Well Name: CEDAR LAKE FEDERAL CA	Well Location: T17S / R31E / SEC 10 / NENE /	County or Parish/State: EDDY / NM
Well Number: 147H	Type of Well: OIL WELL	Allottee or Tribe Name:
Lease Number: NMLC029426B	Unit or CA Name:	Unit or CA Number: NMNM134086
US Well Number: 3001543408	Well Status: Producing Oil Well	Operator: APACHE CORPORATION

Notice of Intent

Sundry ID: 2658751

Type of Submission: Notice of Intent	Type of Action: Plug and Abandonment
Date Sundry Submitted: 02/24/2022	Time Sundry Submitted: 03:55
Date proposed operation will begin: 03/24/2022

WELL BORE INFO.

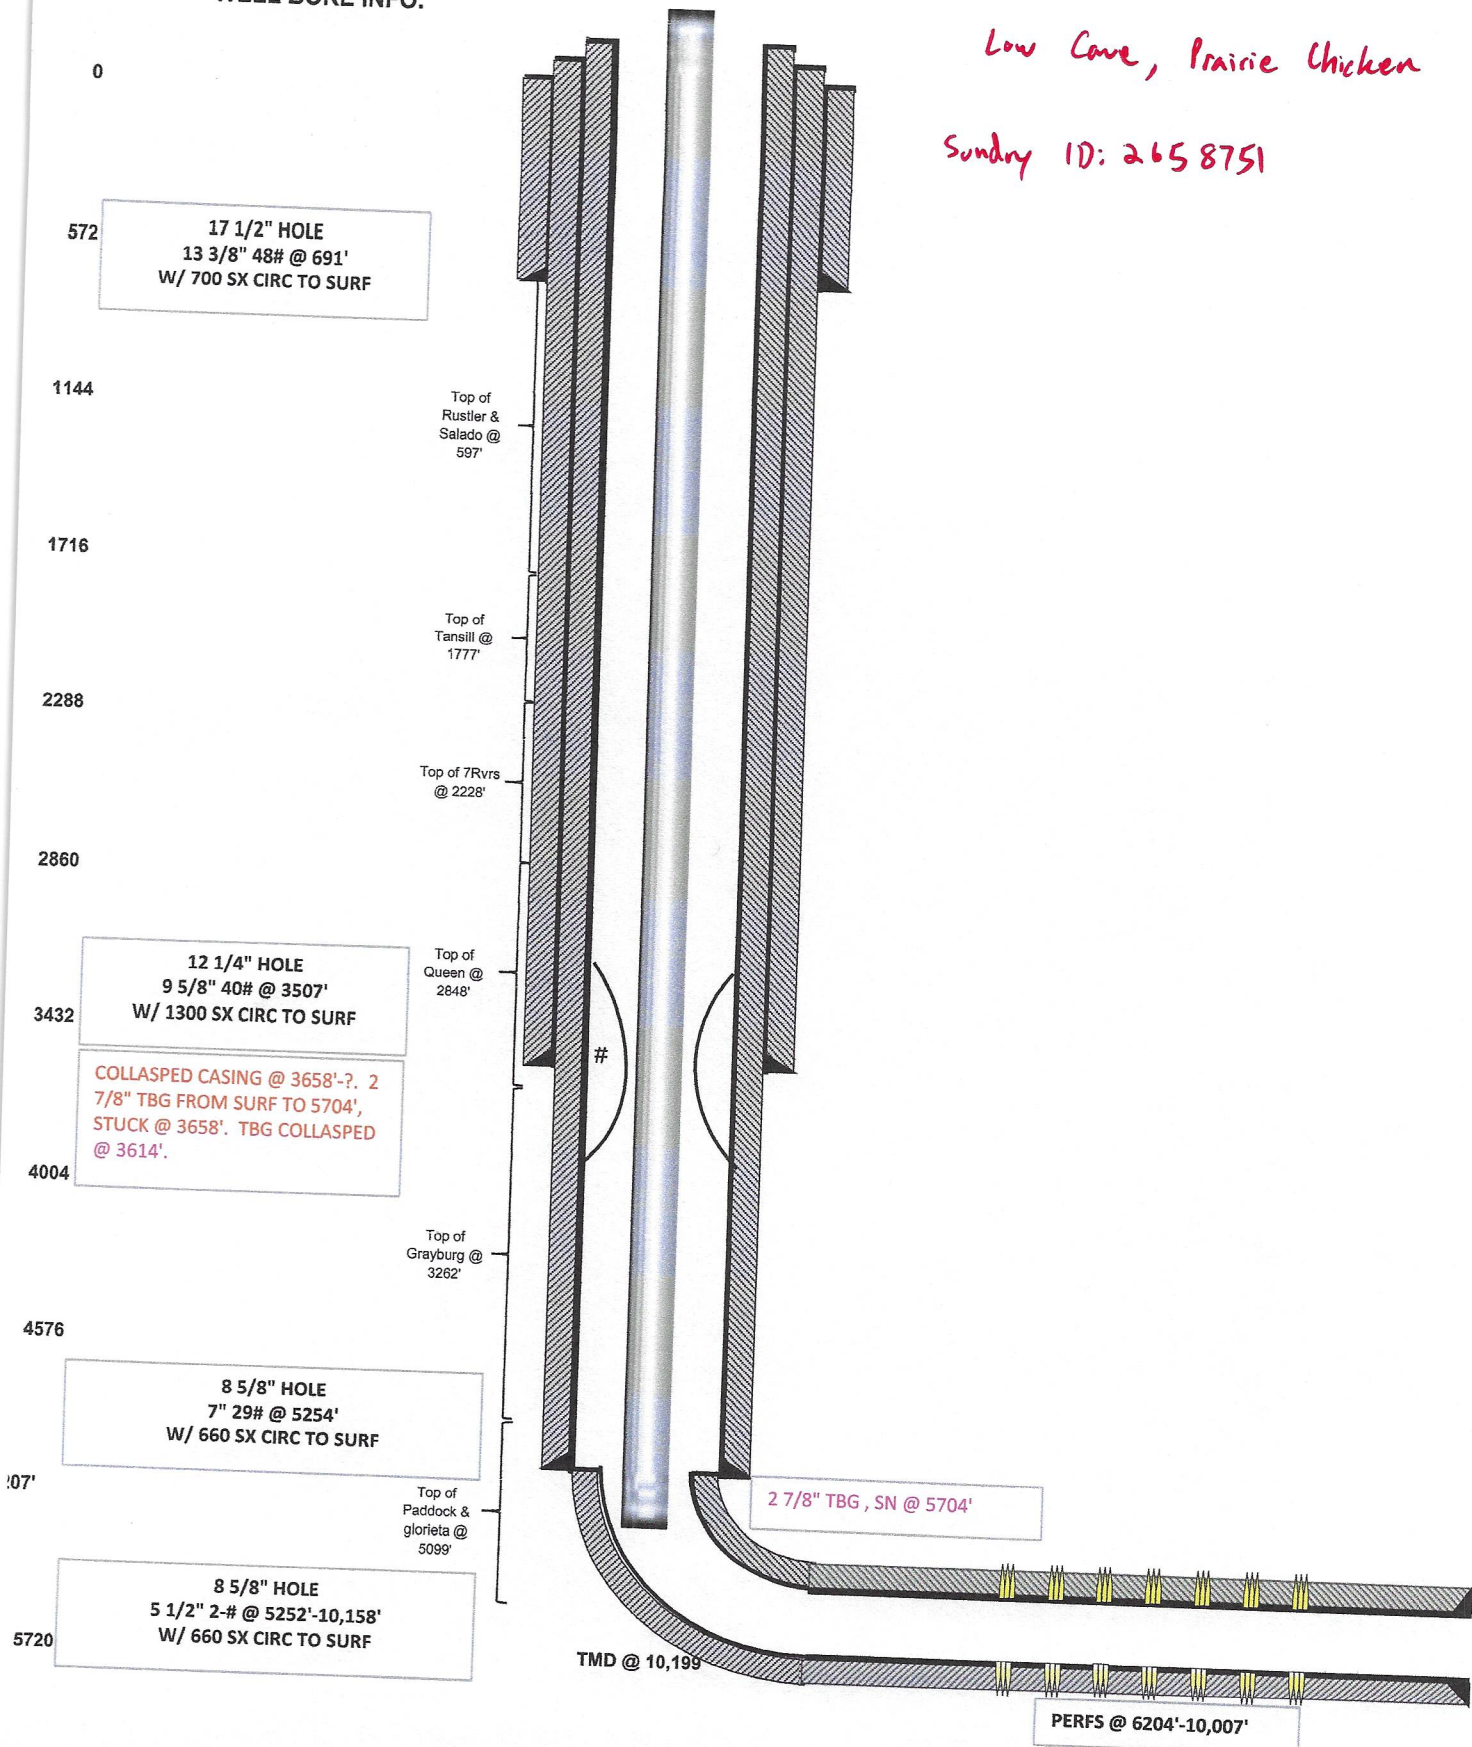
PUH & PERF @ ~~1827'~~ ^{1989'} & SQZ 70 SX CLASS "C"
CMT & DISPLACE TO 1627', WOC/TAG.

MIRU P&A RIG. RIH W/ WL & CUT TBG @
3600', POOH & LD. RIH W/ PKR, EPIR & SQZ 400
SX CLASS "C" CMT & DISPLACE TO ~~3457'~~ ^{3421'}
WOC/TAG (REPEAT SQZ IF NO TAG & STILL
HAVE PIR)

Plug Type	Top	Bottom	Length	Tag	Sacks	Notes
Surface Plug	0.00	300.00	300.00	Tag/Verify	100.00	Perf and squeeze from 300' to surface. Verify at Surface.
Shoe Plug	608.35	715.00	106.65	Tag/Verify		
Top of Salt @ 743	685.57	793.00	107.43	Tag/Verify	90.00	Perf and squeeze from 793' to 547'. WOC and Tag.
Base of Salt @ 1777	1709.23	1827.00	117.77	Tag/Verify		
Yates @ 1939	1869.61	1989.00	119.39	If solid base no need to Tag (CIBP present and/or Mechanical Integrity Test), If Perf & Sqz then Tag, Leak Test all CIBP if no Open Perforations	70.00	Perf and squeeze from 1989' to 1627'. WOC and Tag.
Shoe Plug	3421.93	3557.00	135.07	Tag/Verify
